Amendments to the Drawings

Attachment: Replacement Sheet 1
 Annotated Sheet Showing Changes

FIG. 3

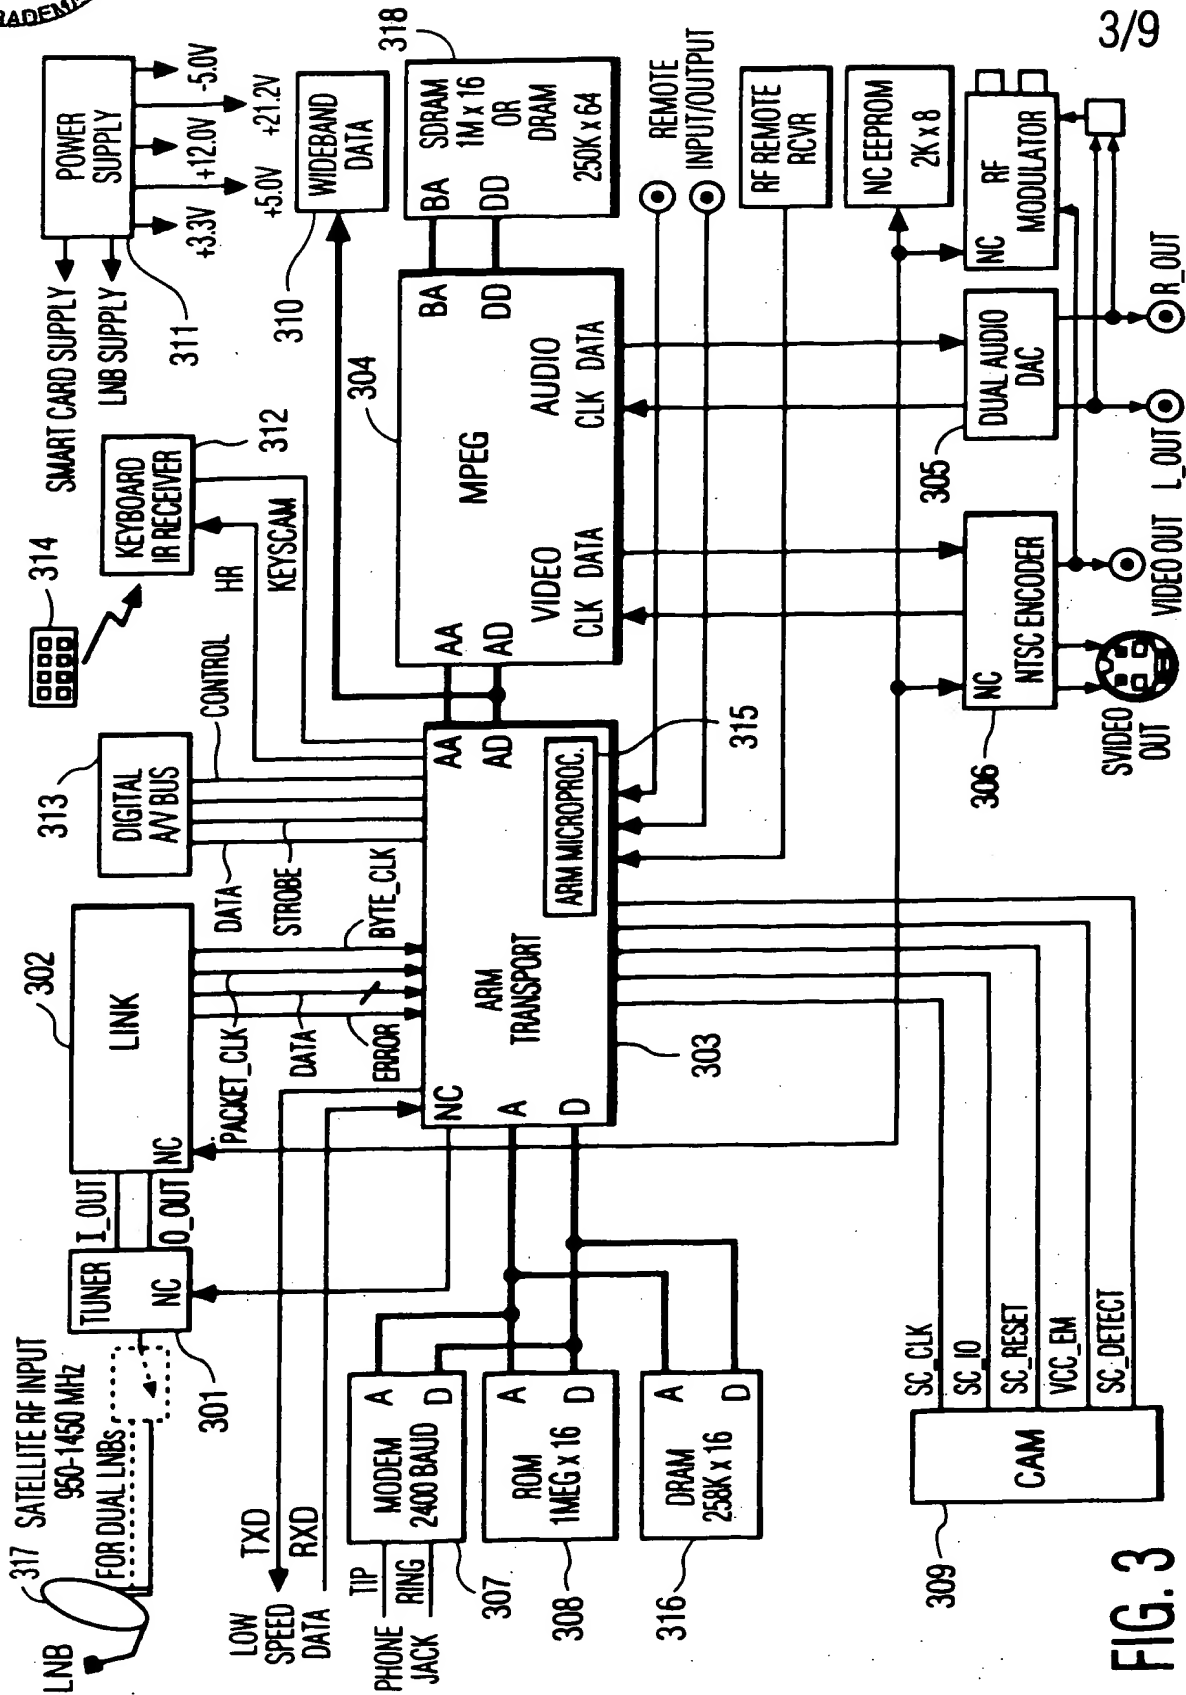
The attached sheet of drawings includes changes to Fig. 3. This sheet replaces the original sheet including Fig. 3. In the replacement Fig. 3, the label for the SDRAM has been changed from 316 to 318.
